IN THE DRAWINGS

Please approve the changes to the drawings in Figures 1, 5, 7, 8, and 11, as outlined in the attached Letter to the Draftsperson, and as shown in the accompanying revised replacement drawings.

FIG.1

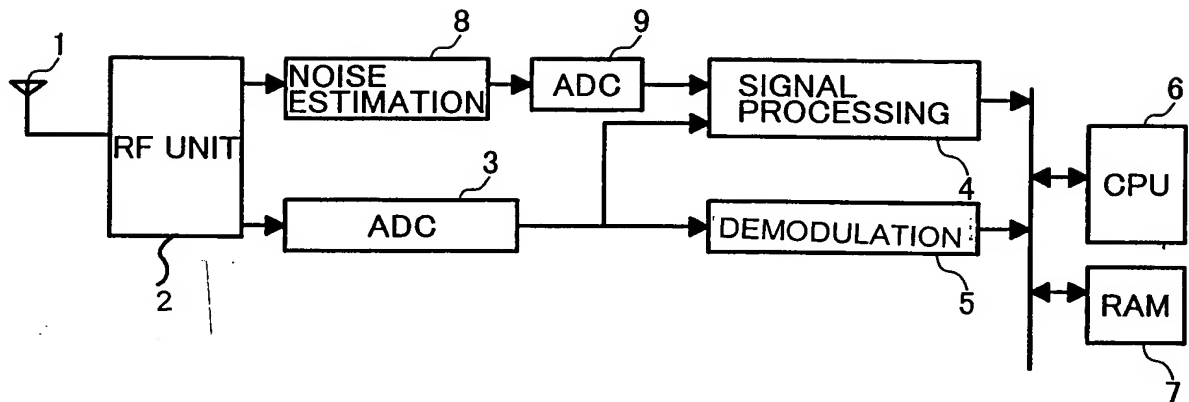
Specifically, in Figure 1, the numeral 2 and lead line therefor have been added and the spelling of the word “demodulation” has been corrected.

FIG.5

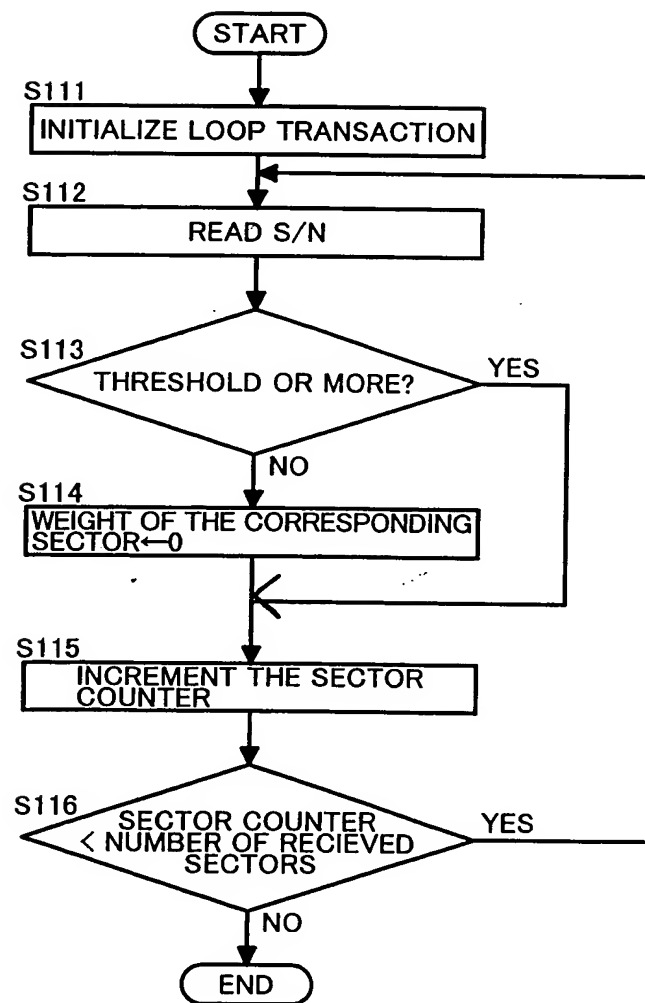
In Figure 5, an arrowhead has been added to a line from the decision block for S113.

FIG.7

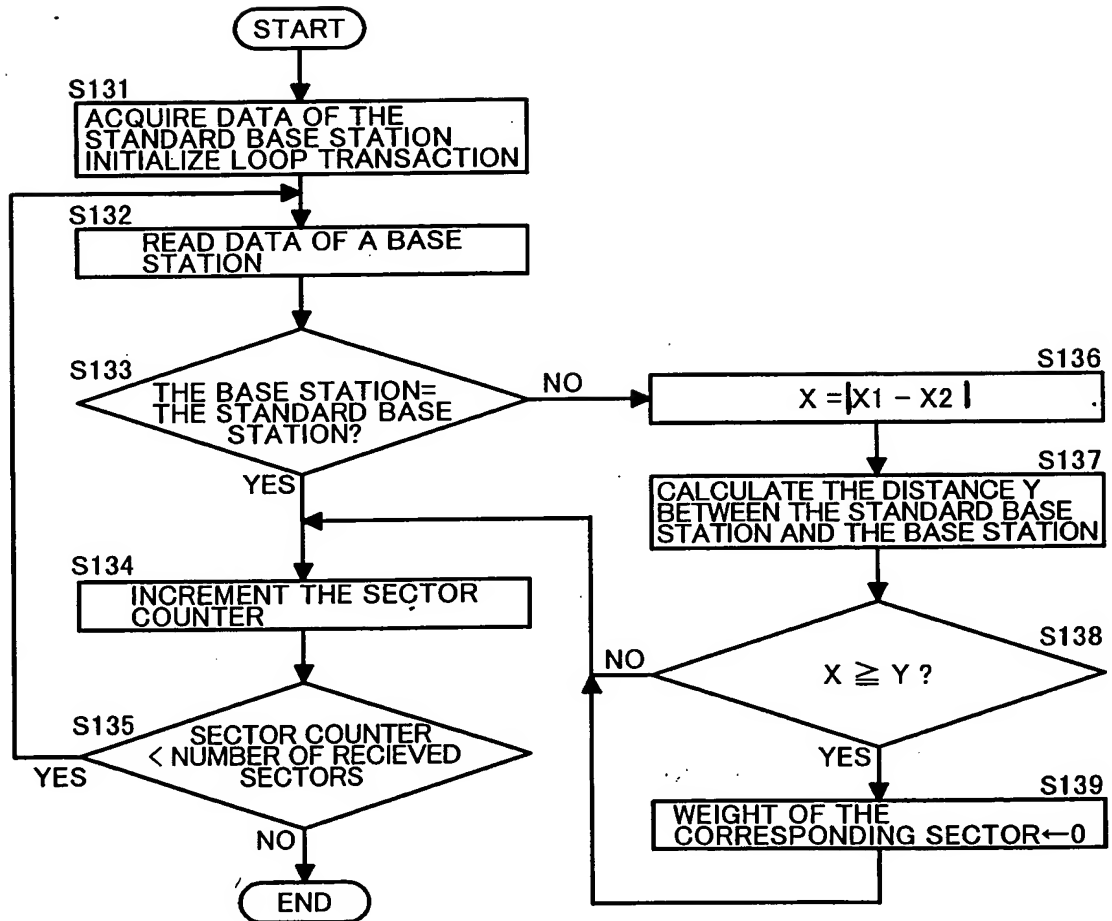
In Figure 7, absolute value lines have been added in the block for step S136.

FIG.8

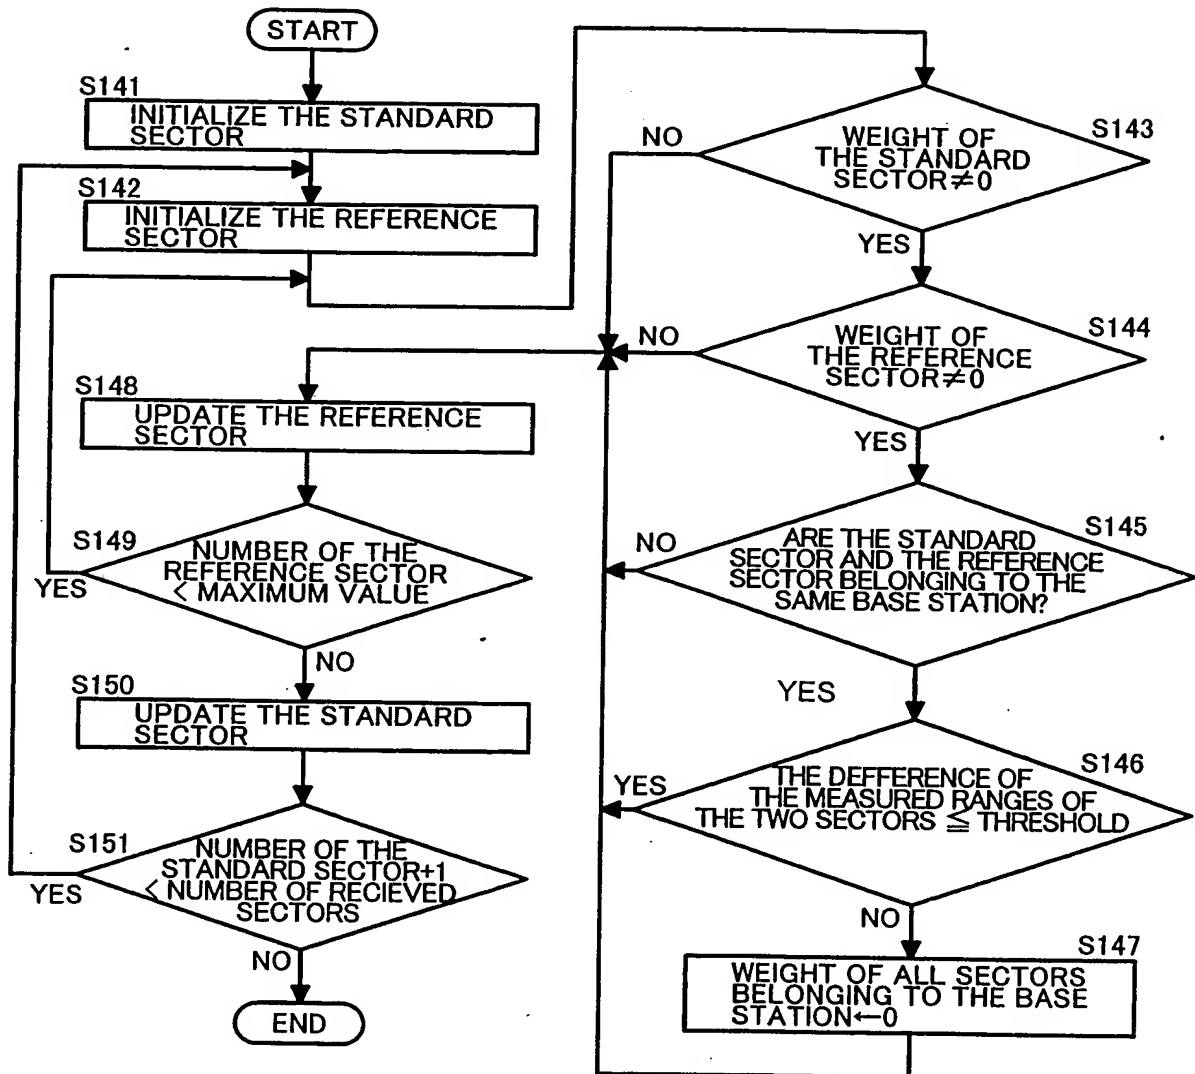
In Figure 8, the word “yes” has been added to identify a line from the decision block for step S145.
